Town of Kittery
Planning Board Meeting
November 18, 2021

ITEM 1—134 Whipple Road—Shoreland Development Plan Review

Kittery Planning Board
Findings of Fact
For 134 Whipple Road
Shoreland Development Plan Review

LANDSCAPE PLAN

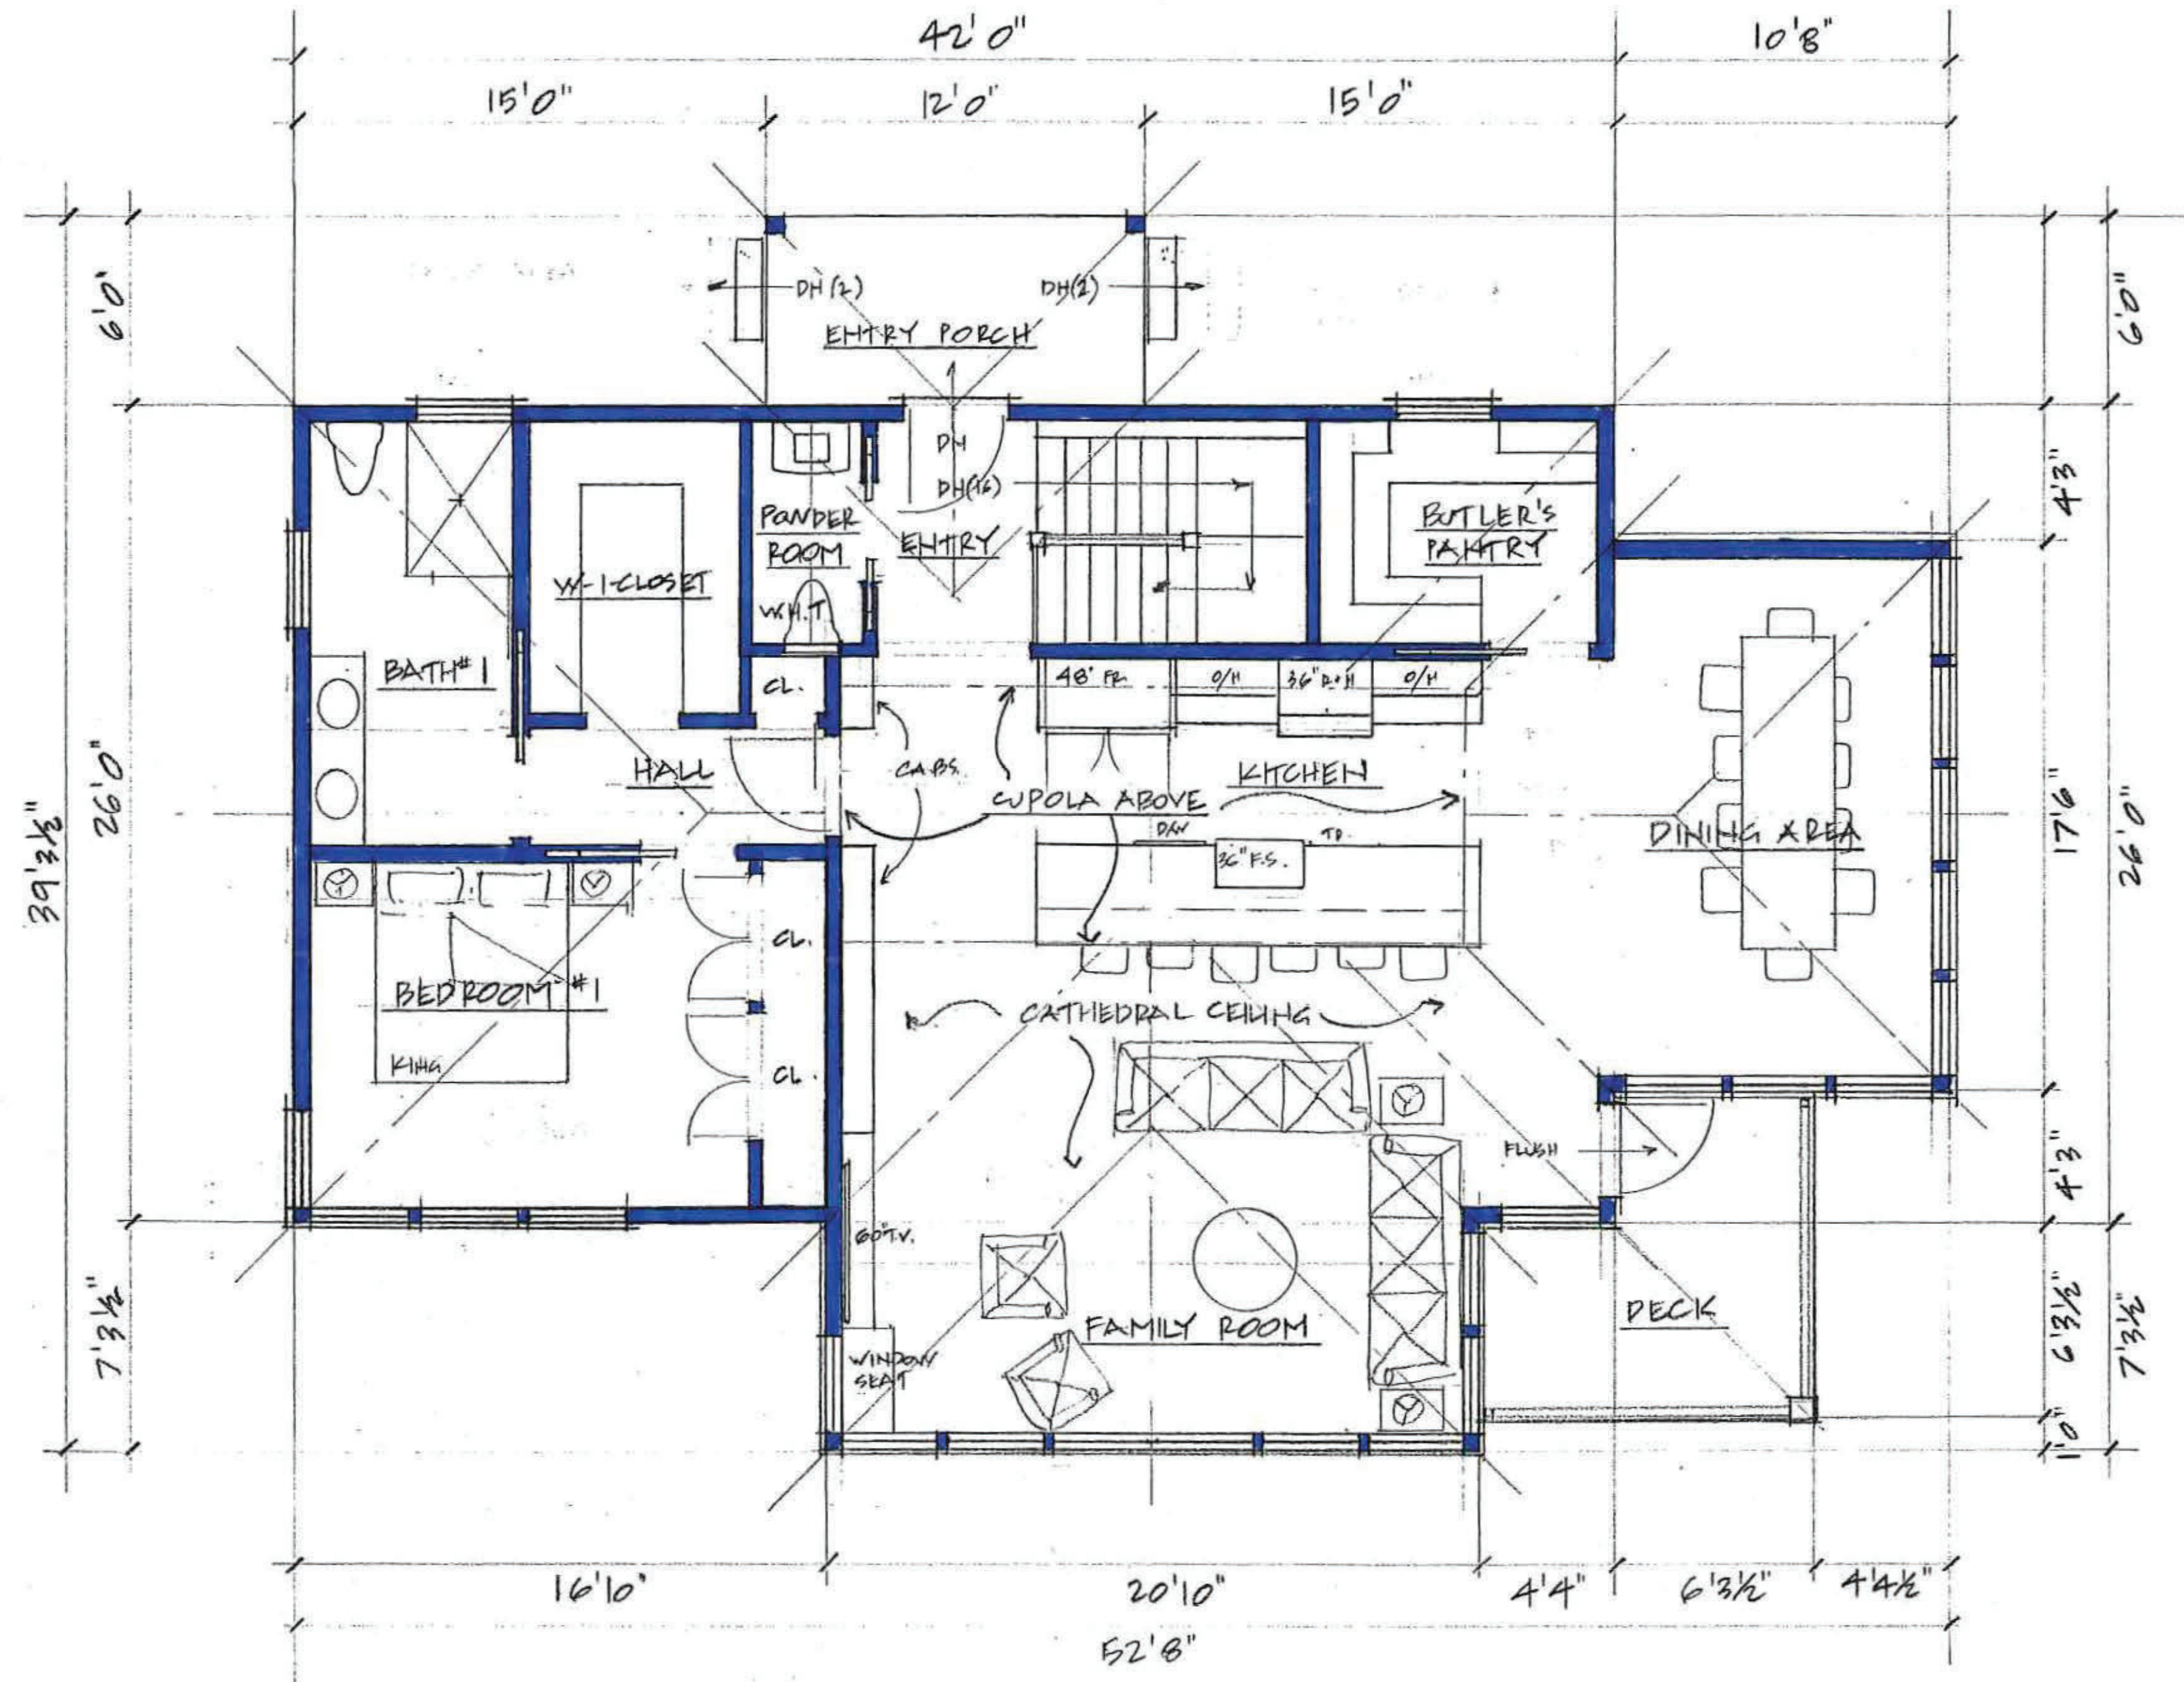
In an updated application, a robust landscaping plan was submitted based on the direction the Planning Board gave the applicant at the August 12, 2021 meeting and the August 26, 2021 site walk. The Planning Board should review the plan and provide comments to the applicant. The last concern the Planning Board had was stormwater runoff. It appears that the combination of drip edge, riprap, and a new vegetation layout will help mitigate any stormwater that falls onto the lot or trespasses from Whipple Road. The Planning Board should discuss the adequacy of the revised plan and whether or not any additional measures should be incorporated into the plan to assist in further stormwater mitigation.
